**OHIO TURNPIKE AND
INFRASTRUCTURE COMMISSION**

ADDENDUM NO. 3
ISSUED JANUARY 28, 2020

PROJECT NO. 39-20-02 (PART A)
MAINLINE PAVEMENT RECONSTRUCTION
MILEPOST 46.50 TO MILEPOST 50.92
FULTON & LUCAS COUNTIES, OHIO
ISSUED DECEMBER 30, 2019

PROJECT NO. 39-20-02 (PART B)
TOLL PLAZA 49 SITE CONSTRUCTION
MILEPOST 48.8 TO MILEPOST 49.1
LUCAS COUNTY, OHIO
ISSUED DECEMBER 30, 2019

INDEX OF SHEETS

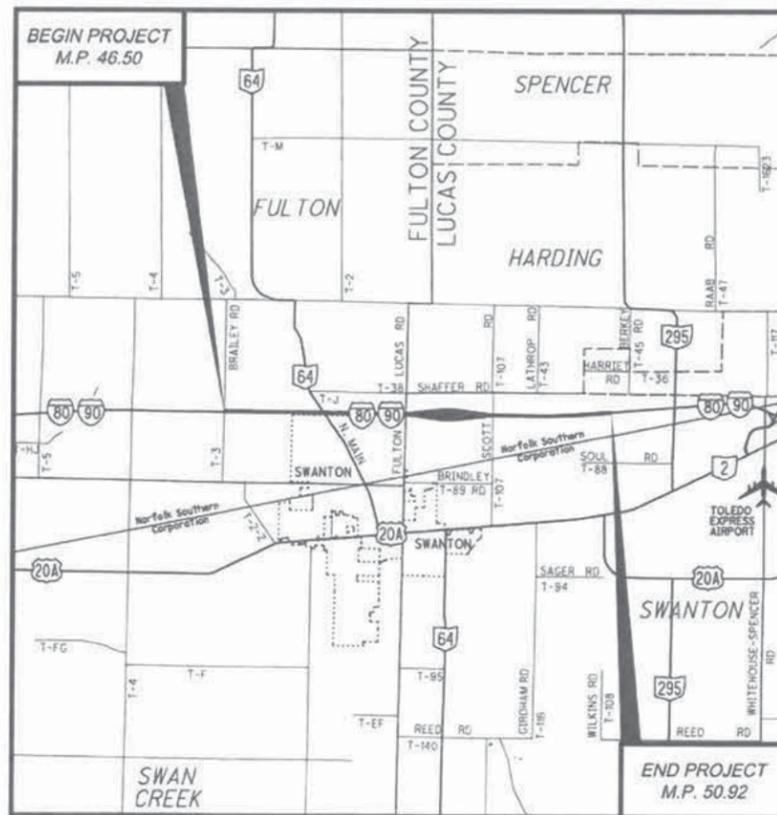
Q#54 Ohio Turnpike and Infrastructure Commission update to Standard Drawing TCR-14.

A#54 This Addendum No. 3 revises the Part A Title Sheet, Plan Sheet No. 1 of 505, to revise the current date of OTIC Standard Drawing TCR-14 to 12-31-19 and provides the revised OTIC Standard Drawing TCR-14, dated 12-31-19.

NORMAL SECTION

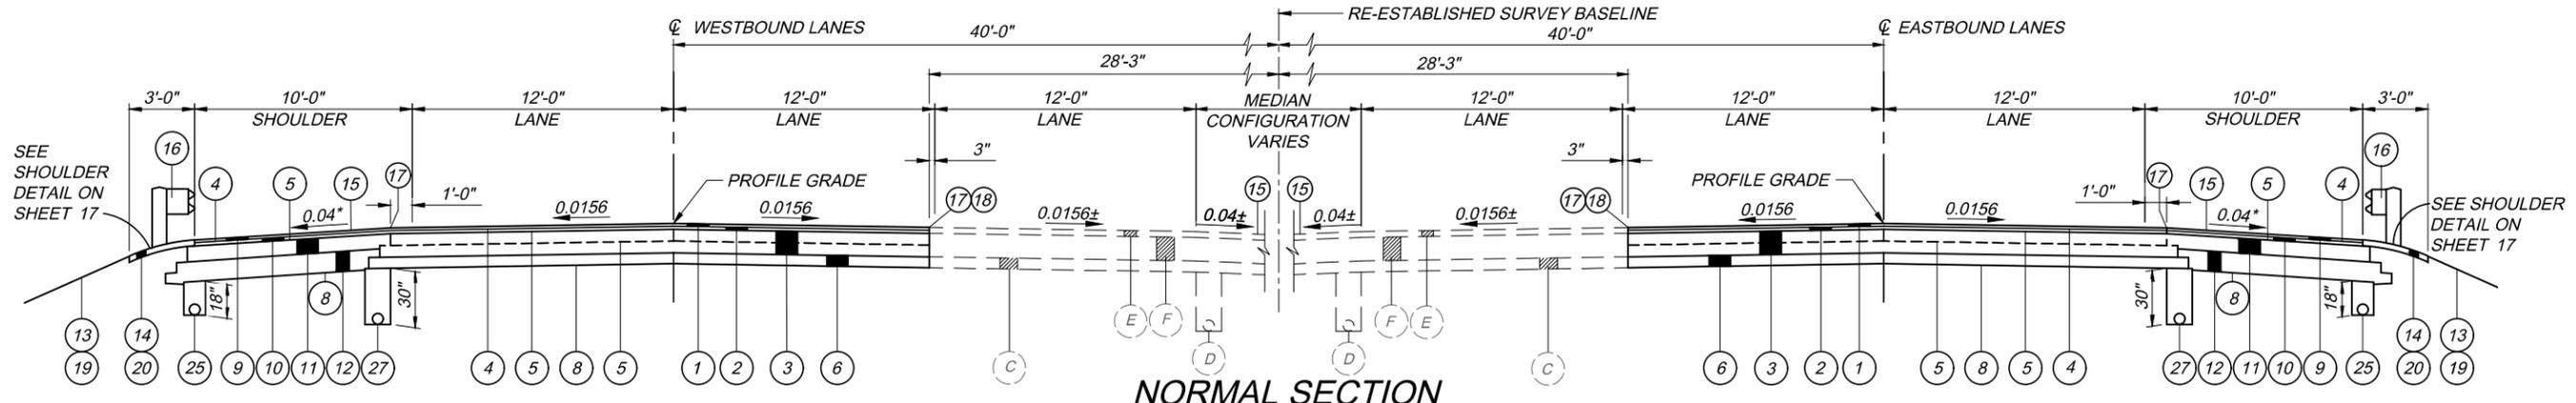
Q#53 Plan sheet 10 on typical sections calls out Topsoil as being 3” thick. Plan sheet 23 Erosion Control notes gives quantities of Topsoil as well as Seeding and Mulching such that it calculates to 4” thick topsoil over seeding area. Please verify if topsoil thickness is to be 3” or 4”.

A#53 This Addendum No. 3 revises Typical Sections Plan Sheet No. 10 of 505 to change Item Legend No. 19 to Item 659 – Topsoil (T=4”).

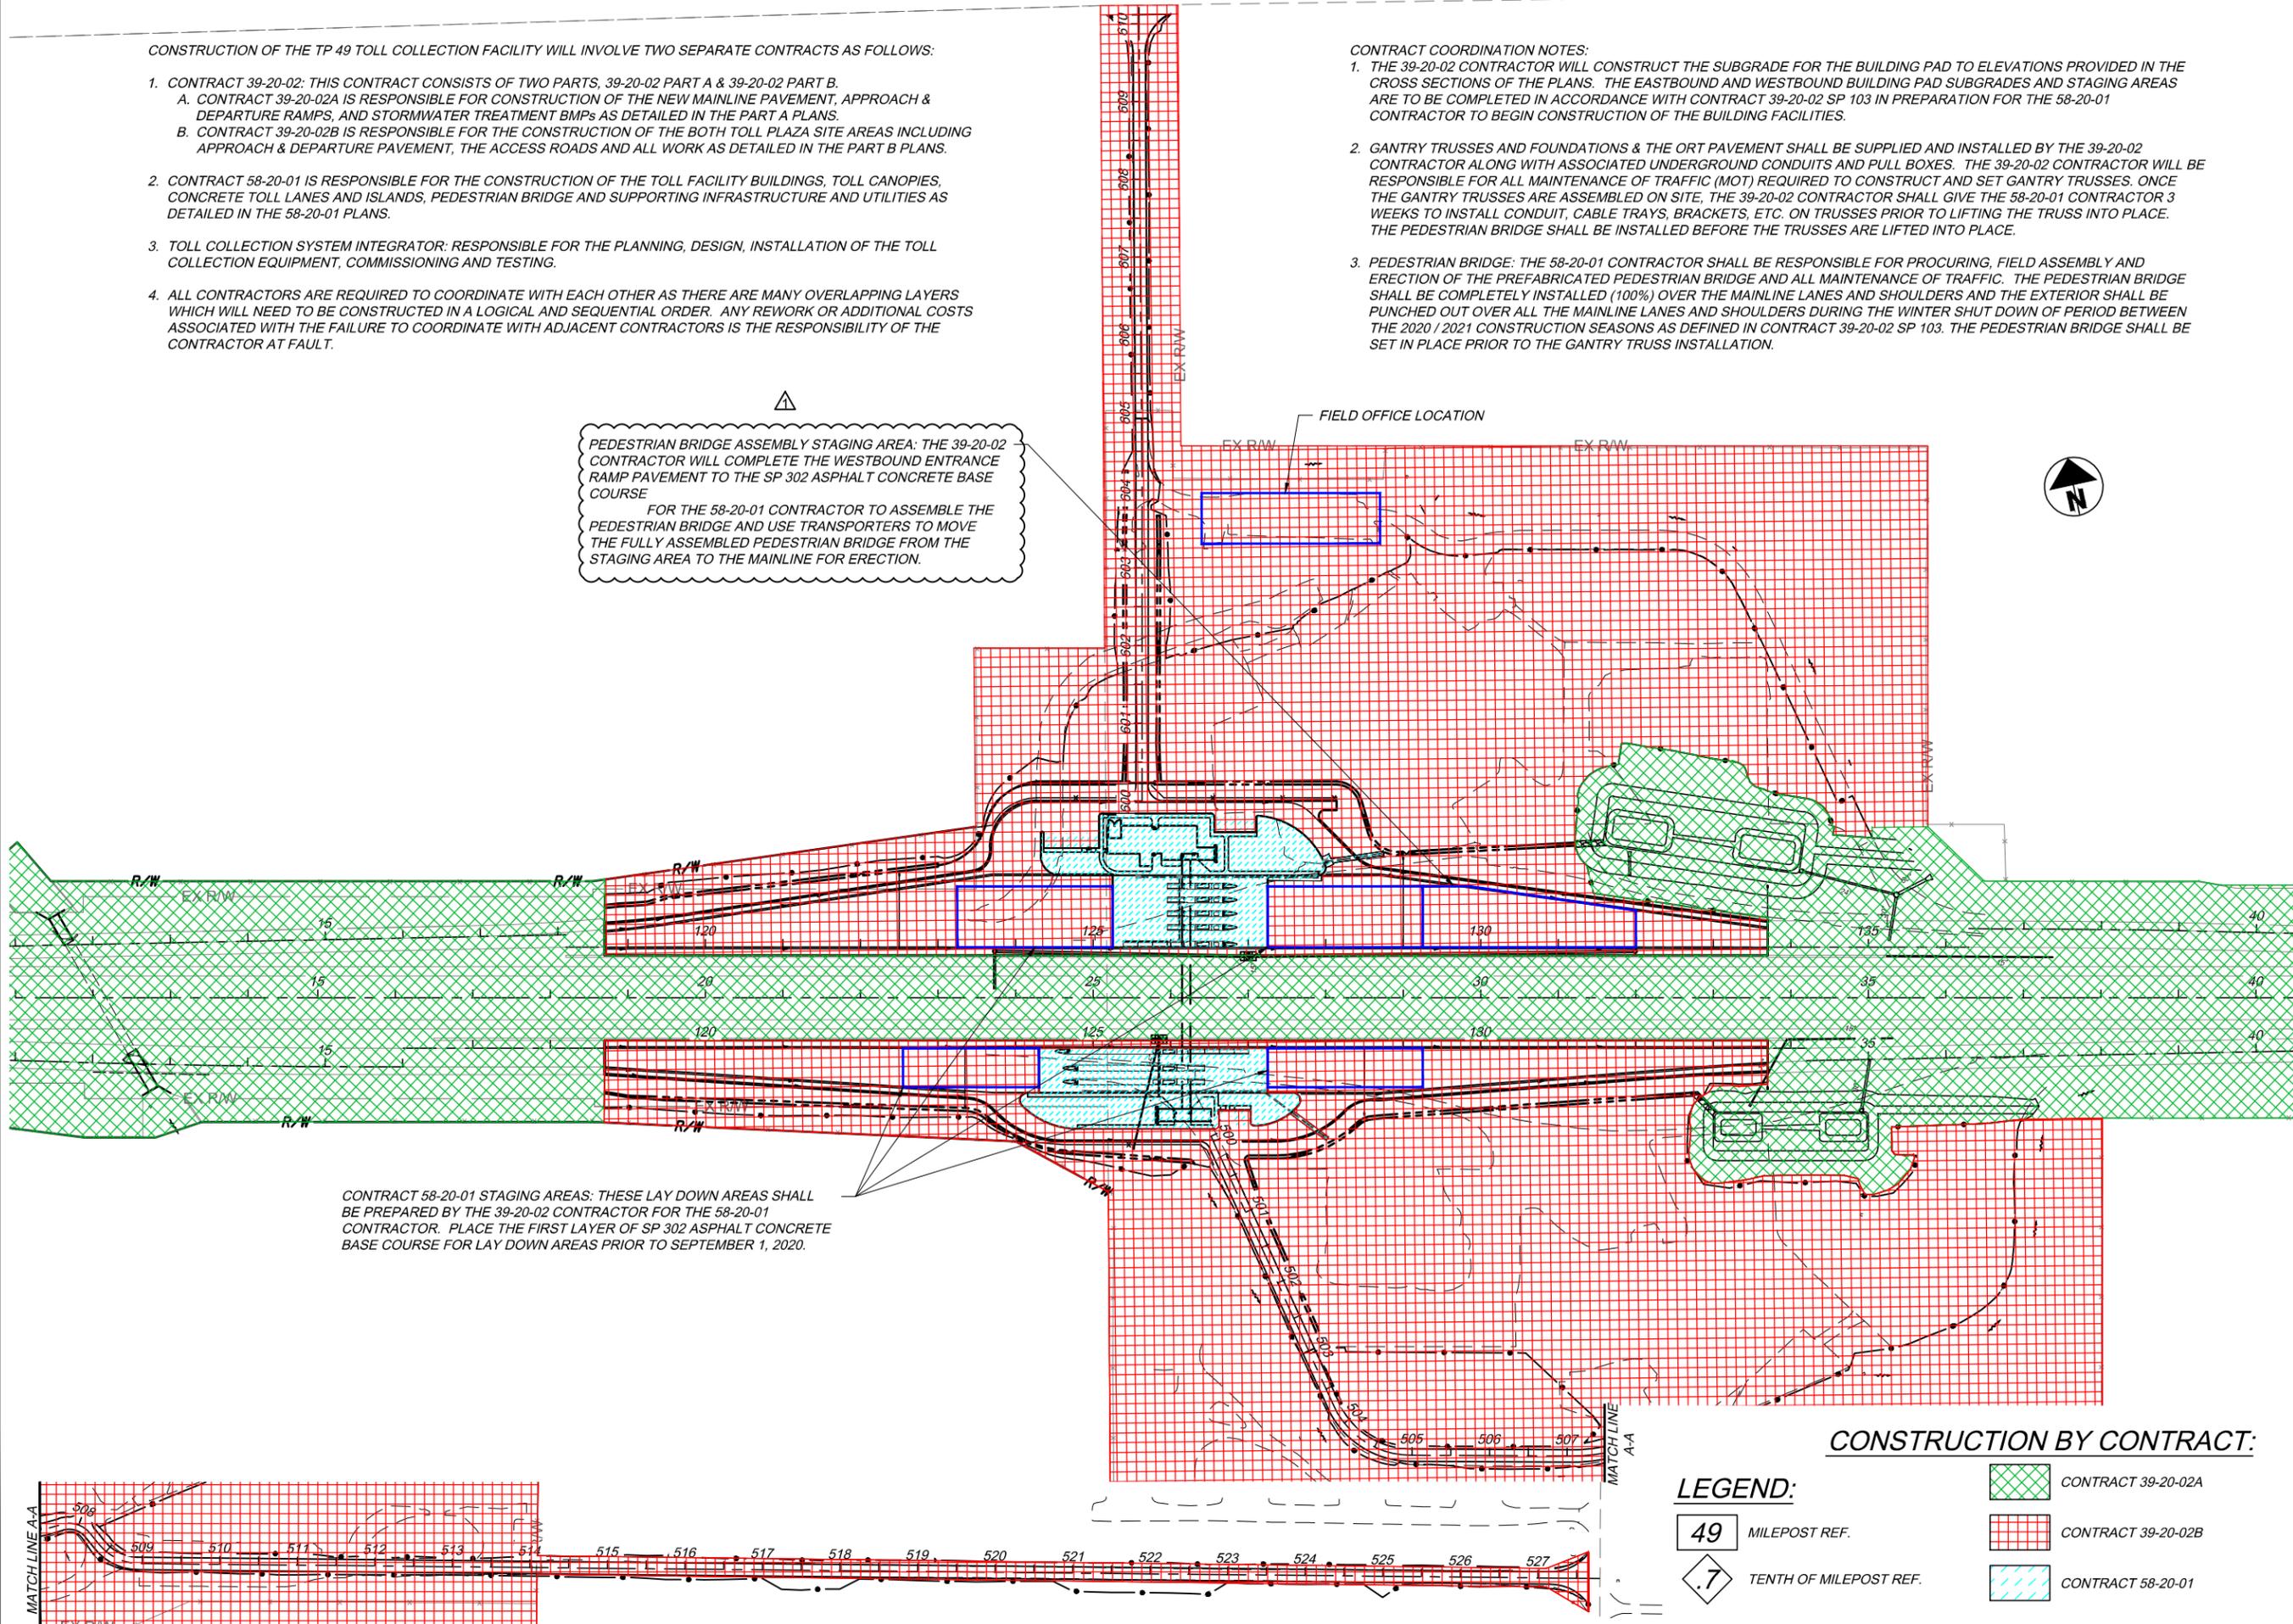
Q#44 Part B plan sheet 9 has notes calling for the contractor to place temporary asphalt wedges over the SP302 at the staging areas adjacent to the staging area. There is no Asphalt for Maintaining Traffic bid item in part B. Will the temporary wedges be paid for under bid item 138 in Part A Asphalt for Maintaining Traffic or will there be similar item added to part B?

A#44 This Addendum No. 3 revises the Part B Contract Coordination Plans, Plan Sheet No. 9 of 59 to remove the language requiring the contractor to place temporary asphalt wedges in the pedestrian bridge assembly staging area.

CRACK AND JOINT DETAILS AT FULL DEPTH CONCRETE REPAIRS

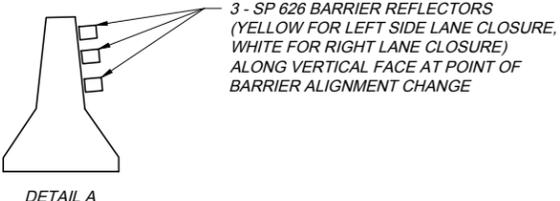
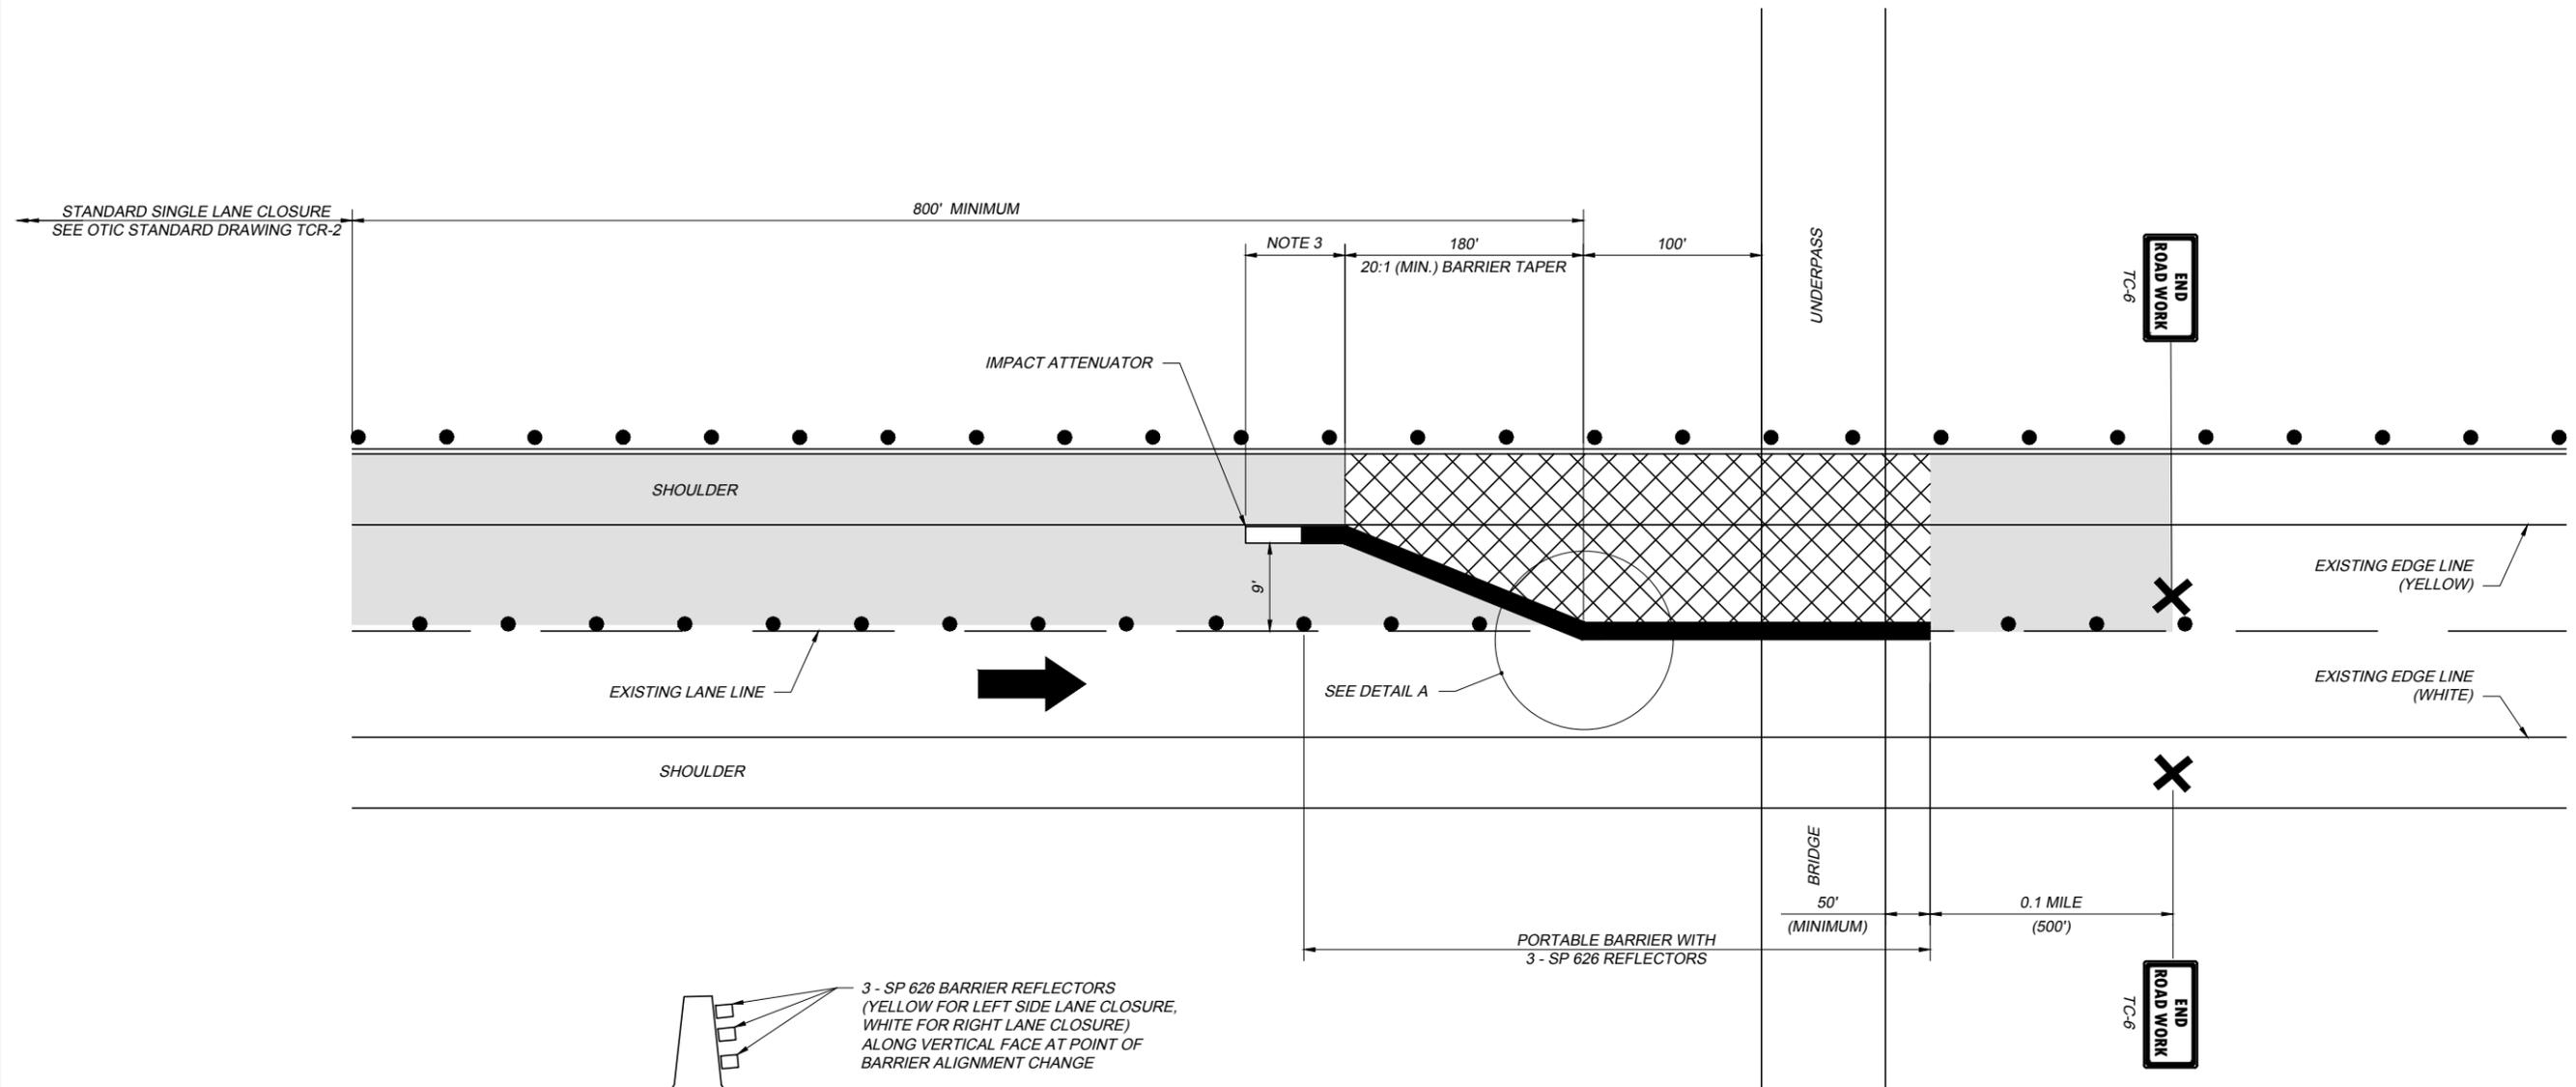
Q#51 On sheet BP-3.1 of the standard drawings (aggregate drain), it does not call out the difference between type 1 and type 2, please clarify?

A#51 This Addendum No. 3 revises the Part A Title Sheet, Plan Sheet No. 1 of 505, to add OTIC Standard Drawing CJ-1 dated 10-20-17. Section AA on Standard Drawing CJ-1 shows that Type 1 Aggregate drains are parallel to the pavement and Type 2 Aggregate drains are perpendicular to the pavement.
